Notification No.: 20130319

Description: iVIZION Acceptance

Hardware: Bezel, Bally Technologies AP-1 VLT

Figure 2 Bezel Molding Process Issues

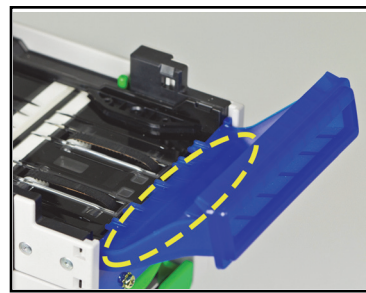
Bally Technologies' Engineering group investigated and identified an issue with the Bezel molding process that allowed expansion of plastic components and bowing to partially block the bill path. Additionally, oversized mating tabs resulted in increased incidents of bill jams in the iVIZION.

The affected Bezel is identified by Bally Part Number 214710-00001, GUIDE,BA,JCM 86MM, CLOACA, BLUE, AP-1.

For additional information and Bezel replacement, please contact the Bally Technologies Help Desk at (877) GO BALLY (877-462-2559) or (702) 584-7785.
